UNITED STATES PATENT AND TRADEMARK OFFICE

APPLICATION NO.	FILING DATE	FIRST NAMED INVENTOR	ATTORNEY DOCKET NO.	CONFIRMATION NO.
10/849,299	05/20/2004	Tamaki Koide	13061-1	5595
23838	7590	06/08/2006	EXAMINER	
KENYON & KENYON LLP 1500 K STREET N.W. SUITE 700 WASHINGTON, DC 20005			KRAUSE, JUSTIN MITCHELL	
			ART UNIT	PAPER NUMBER
			3682

Office Action Summary	Application No.	Applicant(s)	
	10/849,299	KOIDE, TAMAKI	
	Examiner	Art Unit	
	Justin Krause	3682

DETAILED ACTION

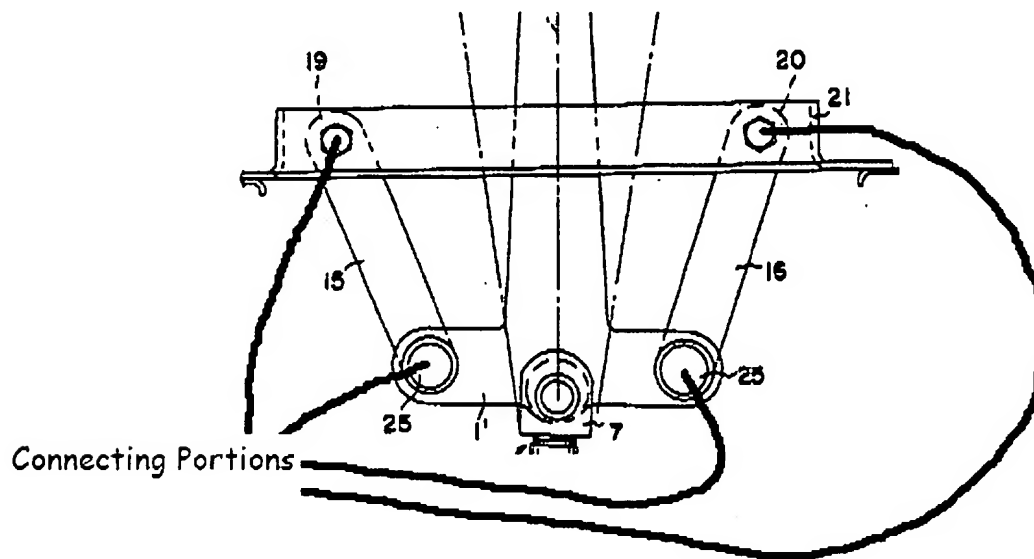
Heizmann discloses a shift lever apparatus comprising:

- a base member (23)
- a shift lever (1)
- at least one planar four bar linkage (21,15,16,1') supporting the shift lever

Regarding claim 2, the planar four bar linkage includes a base-side link element (21), a lever side link element (1') opposing the base-side link and a pair of connecting elements (15,16) connecting the lever-side and base-side link element, the shift lever is supported by the lever-side link, the base member supports the base-side link.

Regarding claim 3, the four bar linkage inherently includes an operational plane in which the four link elements conduct a link motion and the lever-side link is substantially parallelly shifted in the operational plane.

Regarding claim 4, the four bar linkage includes four connecting portions connecting the lever-side link element, the base-side link element and pair of connecting link elements to each other, the four connecting portions having parallel rotation axes.

Regarding claim 6, the operational plane of the planar four bar linkage is movable in a direction perpendicular to the operational plane (See fig 2 or 4)

Regarding claim 7, as best understood, the base link element includes a rotational axis (22) and the operational plane is rotatable about the rotation axis in a direction perpendicular to the operational plane.

Regarding claim 8, the four bar linkage includes an operational plane in which the four link elements conduct a link motion, a base side link element includes a rotation axis and the operational plane of the four bar linkage is rotatable about the rotation axis in a plane perpendicular to the operational plane.
